**THE
NATIONAL
BOARD**
OF BOILER AND
PRESSURE VESSEL
INSPECTORS

NATIONAL BOARD NBIC MAIN COMMITTEE

MINUTES

Meeting of October 25th, 2018
WebEx Online Meeting

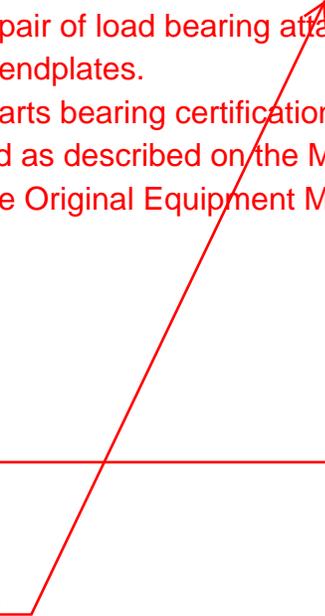
Remove hyphen

Insert apostrophe
